March 13, 2014

Lisa Fay
EIS Project Manager
Minnesota Department of Natural Resources
500 Lafayette Road, Box 25
Saint Paul, MN 55155-4025

Thank you for providing the Minnesota Department of Health (MDH) with the opportunity to comment on the Supplemental Draft Environmental Impact Statement (SDEIS) for the NorthMet Mining Project and Land Exchange.

Figure 1
Known and Estimated Well Locations in Relation to NorthMet Plant Site Surface and Groundwater Flowpaths

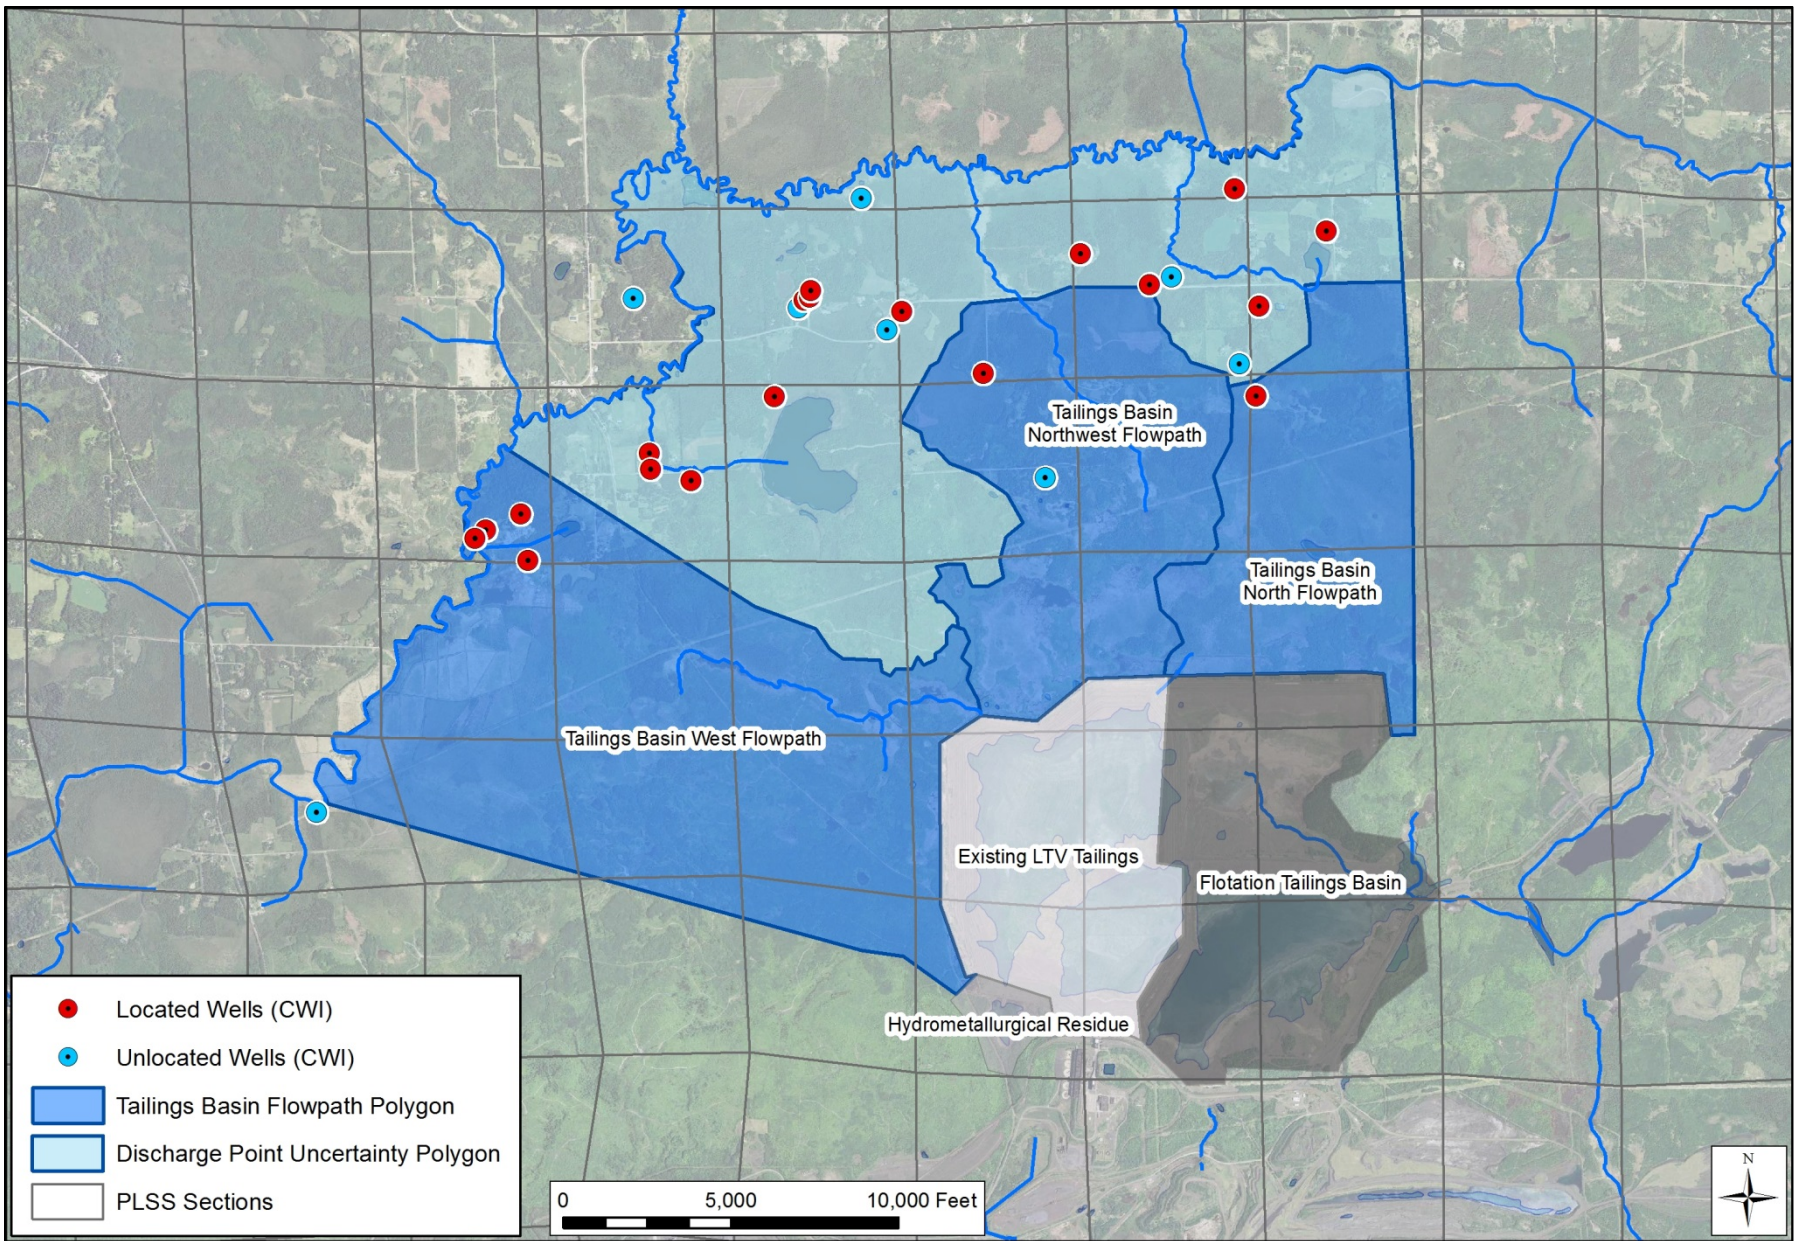
Figures 5.2.2-4 and 5.5.2-6 in the SDEIS outline the groundwater flowpaths along which contamination from the NorthMet mine and plant sites is projected to flow toward the Partridge and Embarrass Rivers. MDH staff conducted a preliminary comparison of these two areas with a search of well locations from the CWI database to assess the impacts that this proposed mining action could have on local domestic wells that are either within the delineated flowpath zones or are between the flowpath zones and the Partridge or Embarrass River. The area between the flowpath zones and the rivers was incorporated into the analysis to address uncertainty in discharge points along tributary streams between the plant and the Embarrass River.

Two sets of well data were assessed: located wells (wells that either have locations verified and recorded using GPS or that have been field-verified to six quarter-sections) and unlocated wells (wells whose locations are estimated based on information provided by well contractors at the time of well construction). Our assessment shows that there were no well records in CWI between the mine site and the Partridge River. However, Figure 1 (attached) shows that 19 located and eight unlocated wells with records currently within CWI met our search criteria for the area between the Plant Site and the Embarrass River, and by inference could be impacted by this mining activity. It should be noted that these numbers likely represent minimum values, as there may be unlocated wells in the area that pre-date the Minnesota state Well Code in either of the modeled zones. These wells that pre-date the code would need to be inventoried, located and input into CWI. Any unused and unsealed wells found during the inventory could be conduits through which a contaminant plume could more quickly propagate, and therefore would need to be sealed as per current Well Code by the parcel owner, possibly with PolyMet Mining, Inc.'s assistance. Also, PolyMet Mining, Inc. should take every opportunity to collect baseline samples for any new wells that might be drilled in the area.

- Provide dissolved oxygen data if available or complete measurement.
- Conduct a thorough inventory and baseline water quality assessment of existing wells prior to the initiation of any mining activities so that any future degradation of drinking water quality related to mining activities can be identified and remediated. This inventory and assessment should include located and unlocated wells.

- Properly seal any unused and unsealed wells found during the inventory.
